Old solution with FT232RL

New solution with FT231XS

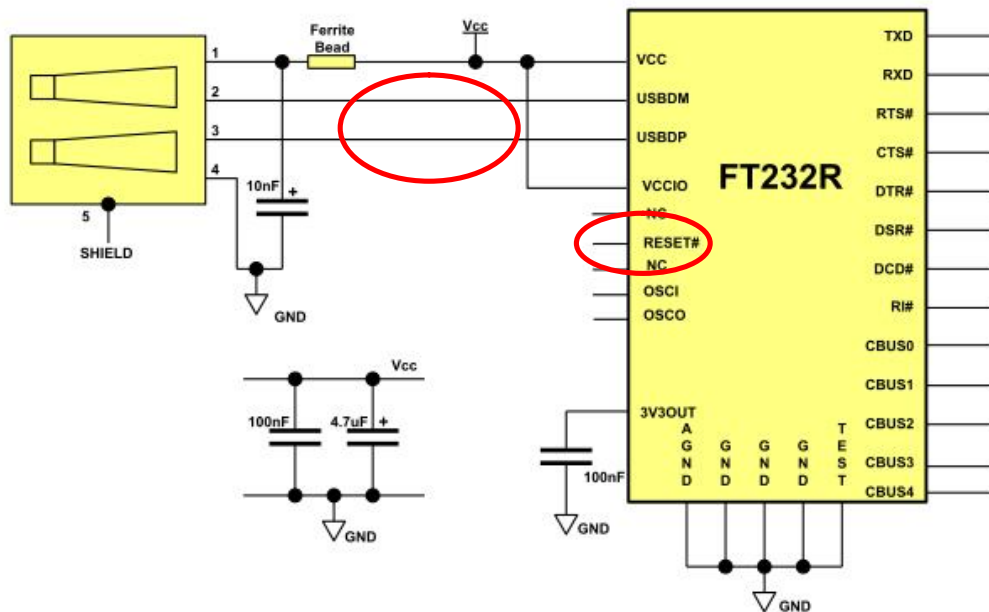
There are no resistors in DM+ and DM- lines and Reset pin is open

There are two resistors (27R) in DM+ and DM- lines and Reset pin is connected to 3V3OUT
